CALIFORNIA COASTAL COMMISSION

SUBJECT: Addendum to staff report for Coastal Permit Application No.
A-1-HUM-96-70 (Moser & Hunt) for the Sand Pointe
Development, Public Hearing Item Th 6a.

Below are additional information and recommended findings to supplement the recommendation contained in the staff report that is dated August 22, 1997. The additional information pertains to: (I) geologic hazards and the adequacy of bluff top setbacks, (II) community character and whether the proposed development is visually compatible with the character of the surrounding area, and (III) the appropriateness of a 20 percent bonus density under the Planned Development designation.

I. Geologic Hazards and Bluff Top Setbacks.

OSCAR LARSON & ASSOCIATES
SITE MAP
DECEMBER 1994
FIGURE 2

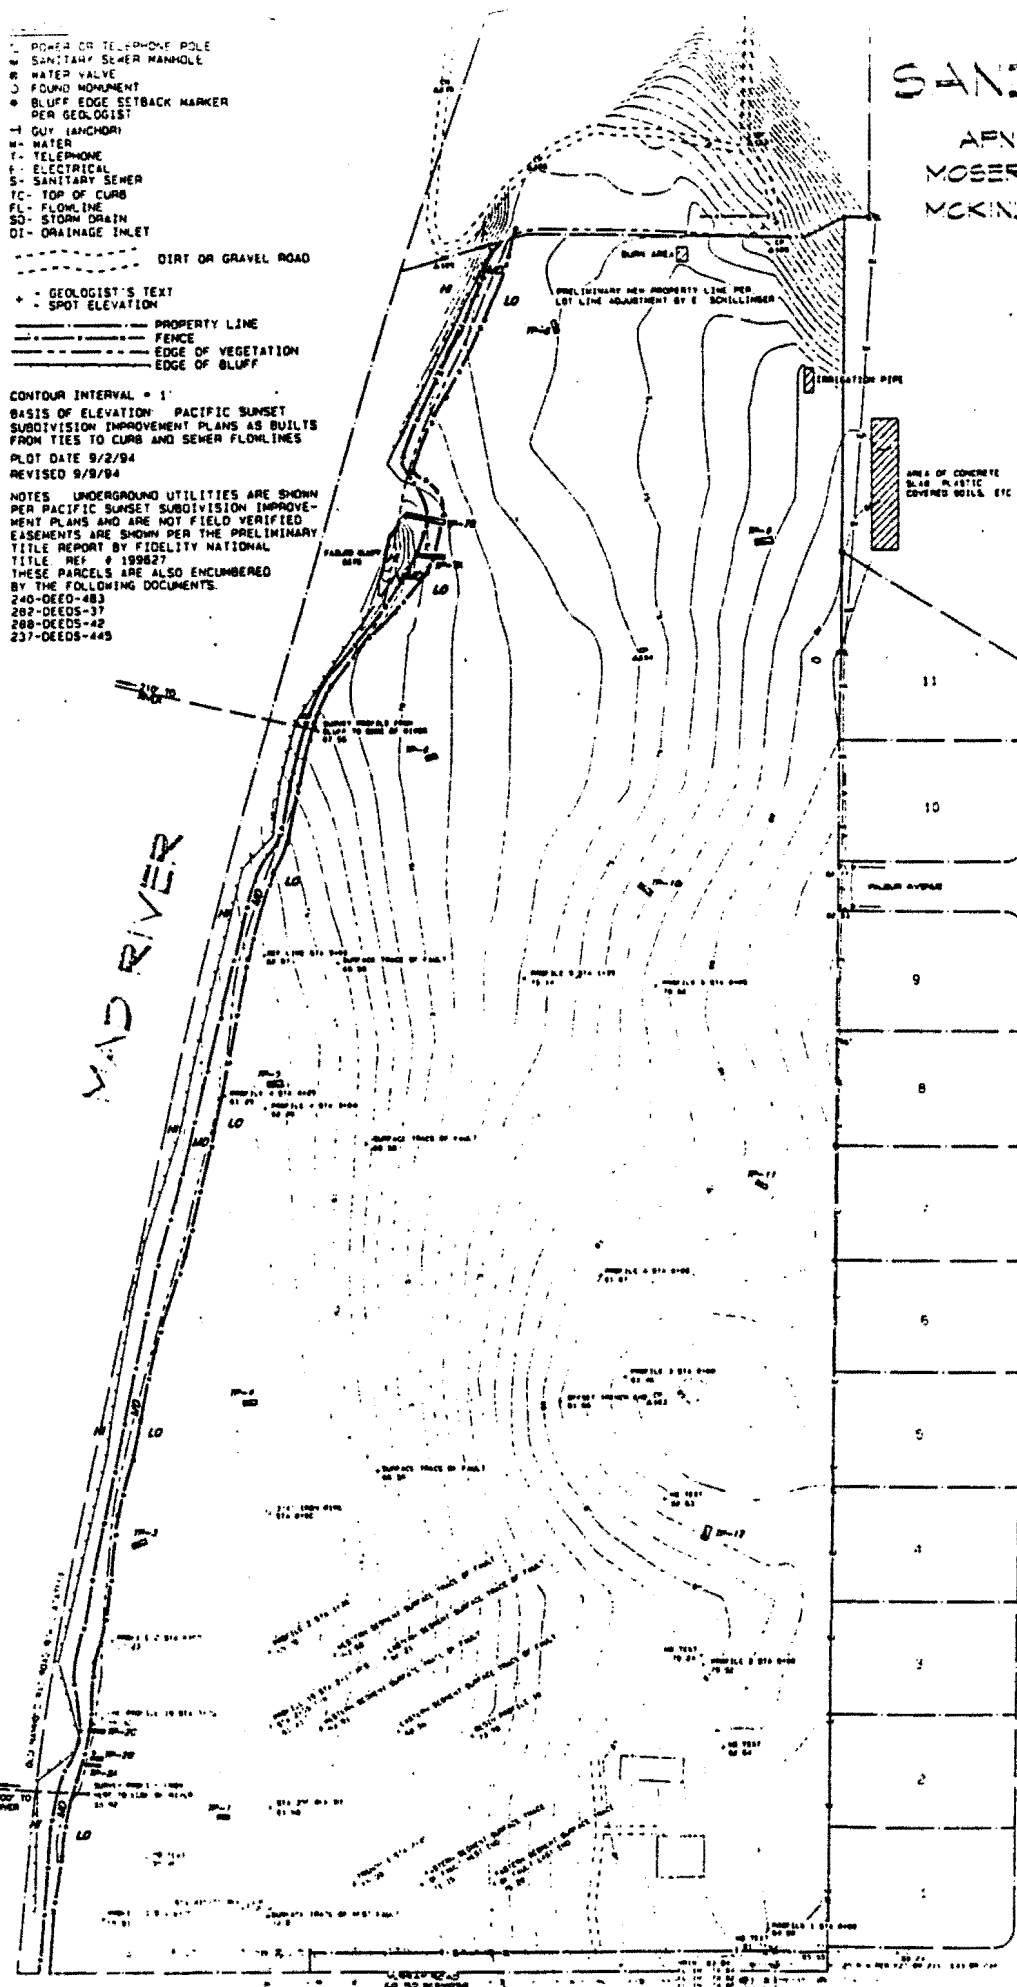
The information submitted by the applicant does not clearly indicate how blufftop setbacks are applied to the project as approved by the County and as proposed to the Commission. For example, if the line of posts was subsequently surveyed on the ground and the results plotted and shown on the tentative map as stated above, it is unclear how the tentative map can show a setback as little as 10 feet and still purport to incorporate the recommended setbacks of 25 to 40 feet. Nine of the 18 residential blufftop lots shown on the tentative map have a minimum setback distance of less than 25 feet. Thus, the bluff top setback line shown on the tentative map would need to be moved landward for at least nine of the 18 lots. However, the minimum bluff top setback distance is more than 25 feet for some lots as the setback distance extends to 40 feet on some lots. The Commission does not know which lots these may be as the bluff top setback is not a set distance from the edge of the bluffs, but rather a variable distance of between 25 to 40 feet. Consequently, the Commission finds that the bluff top setback problem is not necessarily limited to nine of the 18 lots.

The County has conditioned the project to incorporate the recommendations of the geologic report. However, these County conditions are meaningless if the geologic report does not provide and show an accurate bluff top setback line. For example, as approved by the County, Condition No. 1 of the local coastal development permit requires that:

Referring to paragraph 2; bluff retreat rate--the setback distances indicated on Figure 2 of the 1995 SHN geotechnical report are the accumulation of a number of factors which contribute to bluff slope instability. Examples are, direct rainfall erosion effects, low rate soil creep of vegetated slopes, shallow failure caused by very strong earthquakes, and movement of a saturated soil and root mat on steep slopes due to extraordinarily heavy rainfall. The portion of the setback attributed to chronic, regular, erosion processes was determined to be 5 feet over a 50 year period. Since we had not observed the recent history of the bluff slope and were not sure how the Hammond Trail was going to be constructed, we decided to be cautious and double the "chronic erosion" portion of the setback to 10 feet. On the basis of recent observations, we conclude that the extra caution was not warranted. Therefore, extending the reference from 50 to 75 years results in 7-1/2 feet of setback due to "chronic erosion" processes and another 2-1/2 feet to maintain a level of conservatism. Therefore, no change in the recommended 10 foot setback due to extending economic lifespan from 50 to 75 years is warranted.

BLUFF SLOPE PROFILES

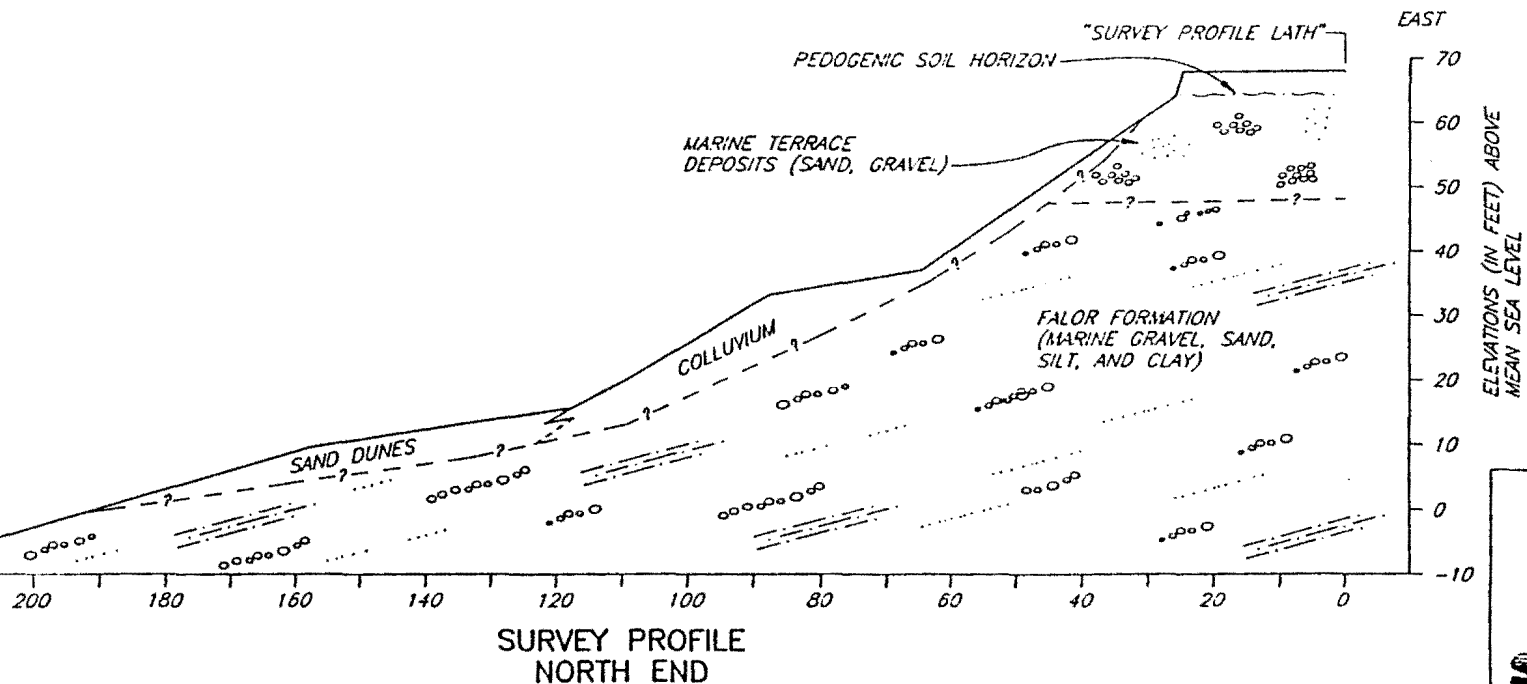
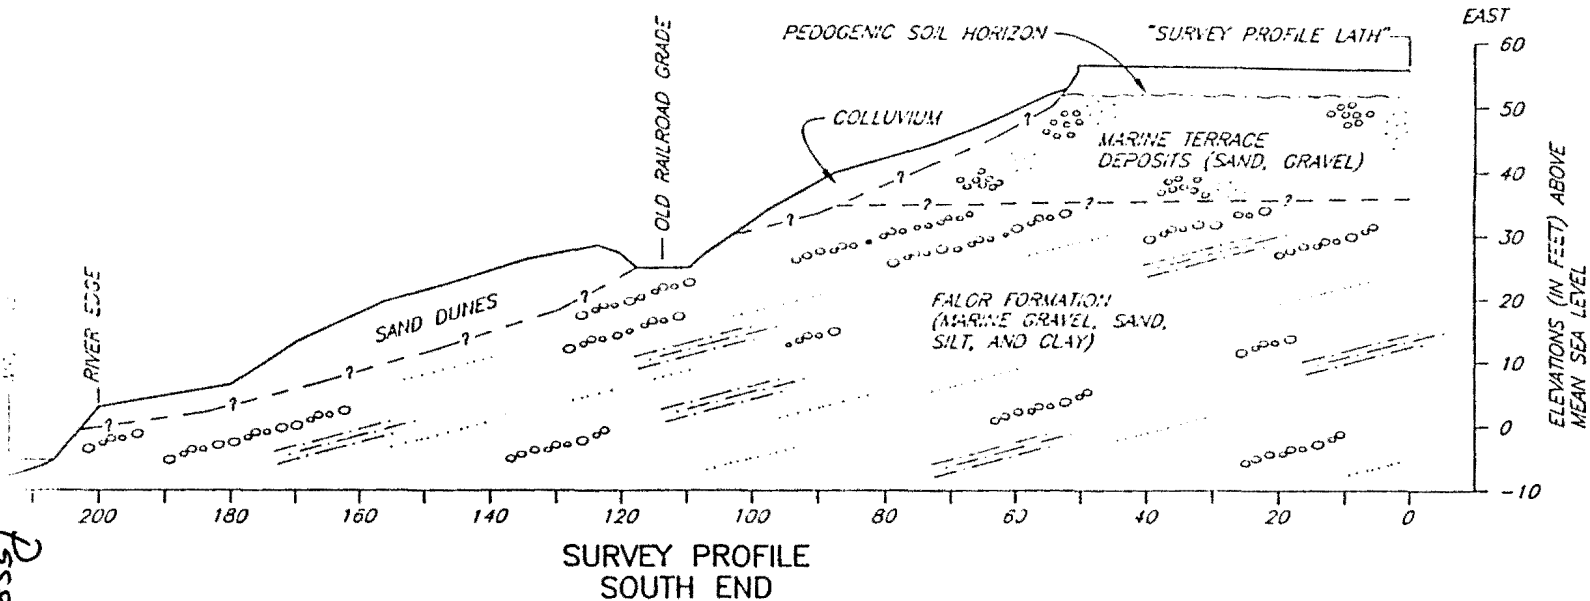
The Commission notes that the geologic report has a discussion about "Bluff Retreat Hazards" on page 10 of Exhibit No. 15. This section states in applicable part that: "Minor variations of a few 10's of feet should be expected during the economic lifespan of the project." The response by SHN to staff requests for clarification is on page 3 of Exhibit No. 46, and it states in applicable part: "This statement is in reference to the amount of river bank erosion that should be anticipated, and does not relate directly to retreat at the bluff top." Consequently, because this statement actually refers to river bank erosion and not erosion of the bluffs, and because no other rates of bluff top erosion or setback distances are mentioned in the geologic report, the Commission concludes that the geologic report does not establish any particular rate of bluff retreat or any particular setback distance.

SHN's letter of clarification in Exhibit No. 46, pages 2 and 3, doe provide some information about bluff retreat. The letter goes on to explain that the bluffs had a "worse case" retreat of 10 feet during the 40-year period between 1941 to 1981 and a "worse case" retreat of 2 feet during the 14-year period between 1981 to 1995. Consequently, there is evidence to suggest that the bluffs have retreated up to a distance of 12 feet in 54 years. Notwithstanding this additional bit of information, the Commission finds that there is nothing in either the report or SHN's two letters of clarification that provides a connection between this retreat rate and the recommended setback distances of 25 to 40 feet.
